Comal County Environmental Health

Permit of Authorization to Construct an On-Site Sewage Facility Permit Valid For One Year From Date Issued

HAVENWOOD AT HUNTERS CROSSING, UNIT 1, LOT 94

RE: Permit #116772
2615 LIONS DEN
HAVENWOOD AT HUNTERS CROSSING, UNIT 1, LOT 94
HAMILTON RESIDENCE

OWNER:	NICHOLAS MATTHEW & NICOLE LEEANN HAMILTON					DRAWN BY:	EJS III/GWJ
STREET ADDRESS:	2615 LIONS DEN						
LEGAL DESC:	HAVENWOOD at HUNTERS CROSSING			UNIT/SECTION/PHASE:	1	BLOCK:	LOT: 94
PREPARED BY:	GREG W. JOHNSON, P.E. F#002585		SCALE:	1"=40'	DATE:	3/5/2025	REVISED: 5/4/2025

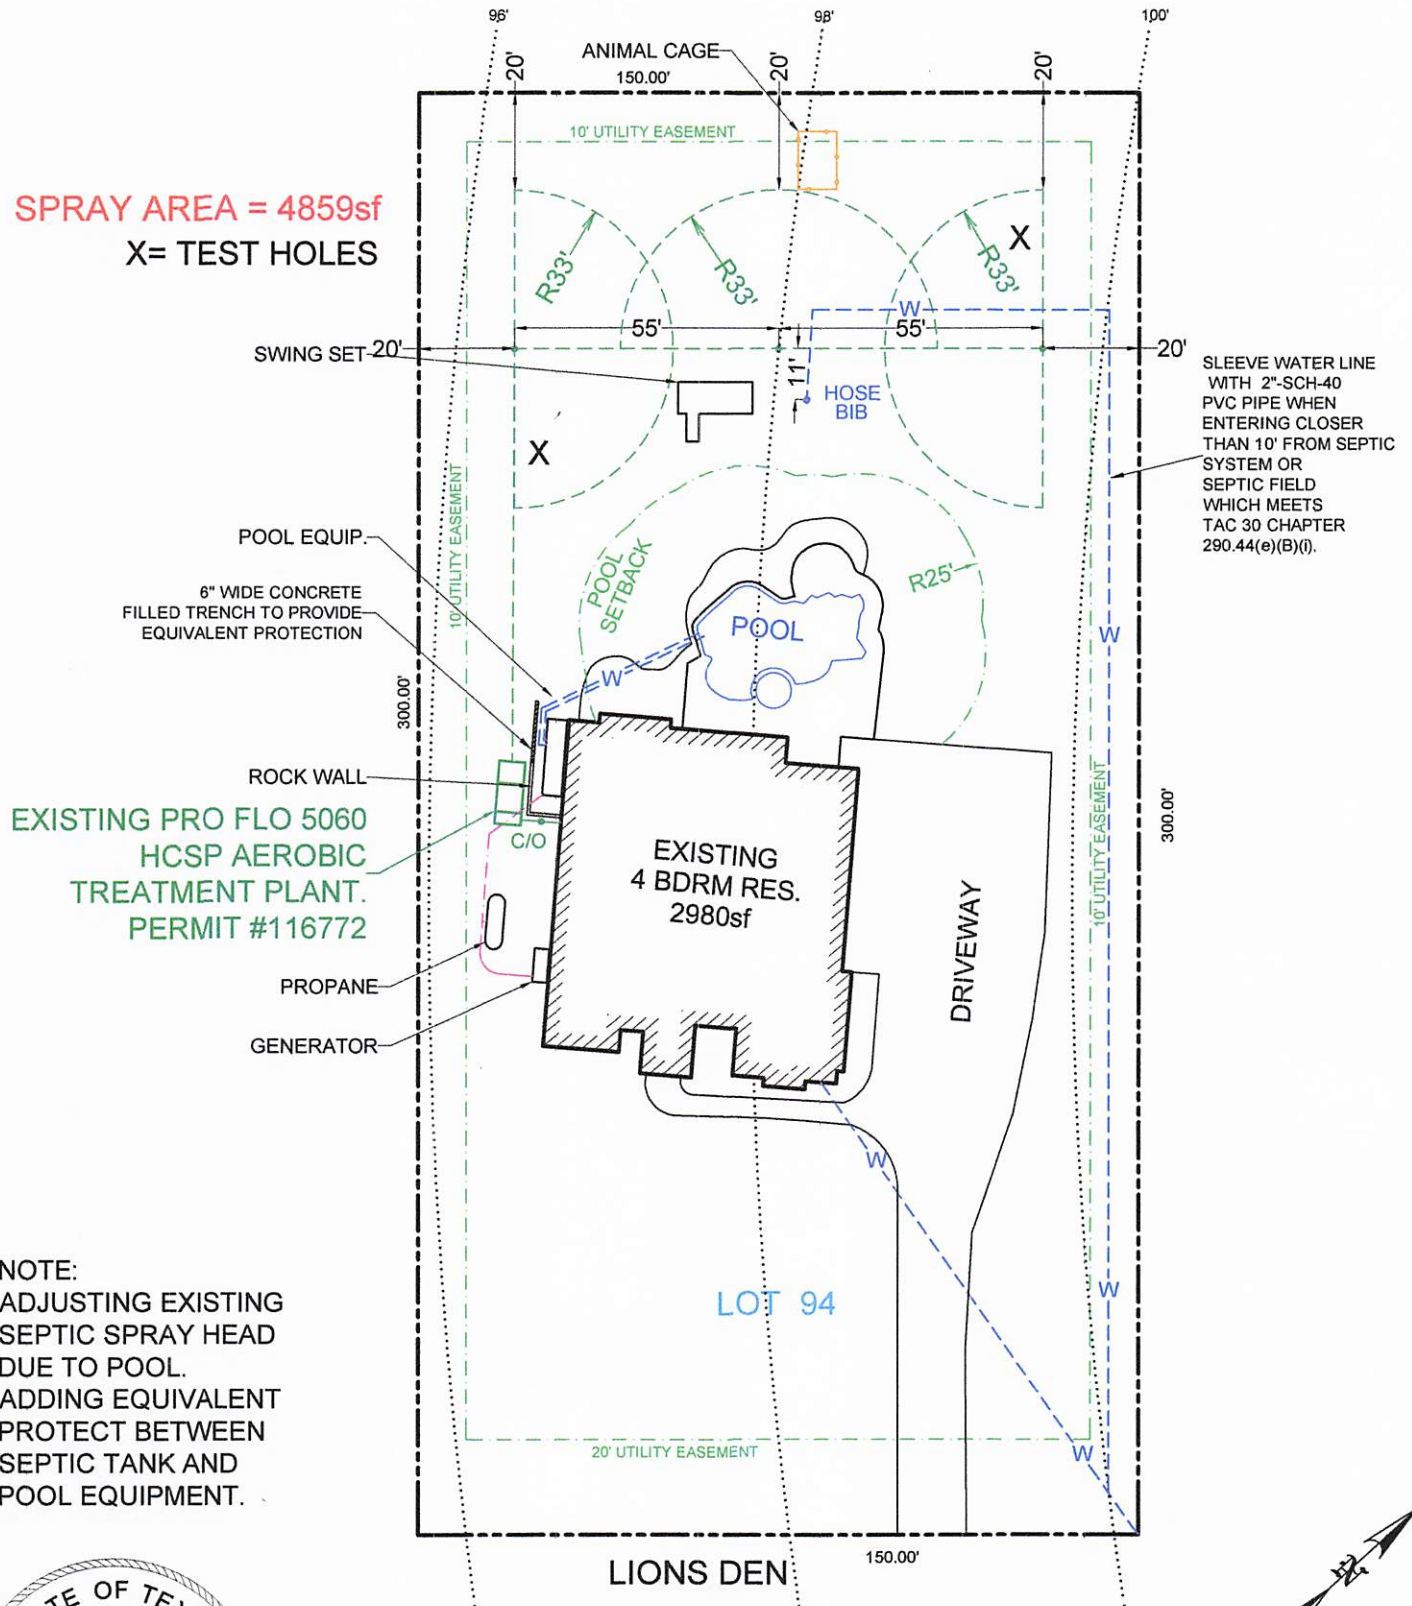
Owners have installed a concrete wall around the pool equipment pad that is within 5' of one side of the aerobic tank. The tank and sewer line were installed before the decorative wall was constructed. Placement of the septic tank will not harm the wall because the tank was installed first and the decorative wall is not a foundation. Additionally, the placement of the wall will not negatively affect the integrity of the tank or sewer line. In my professional opinion the installation of the decorative concrete wall closer than the five foot setback requirement will not pose a threat to the public health or environment.

Owners have installed pool lines from the pool equipment pad less than ten feet from the aerobic tank. I proposed to excavate a thirteen foot long rock saw trench to solid rock, (~approximately 12" deep) centered between the tank and pool lines and fill with concrete to provide equivalent protection between tank and pool lines.

I hereby respectfully request a variance to ten foot setback between pool lines and aerobic tank and effluent line.
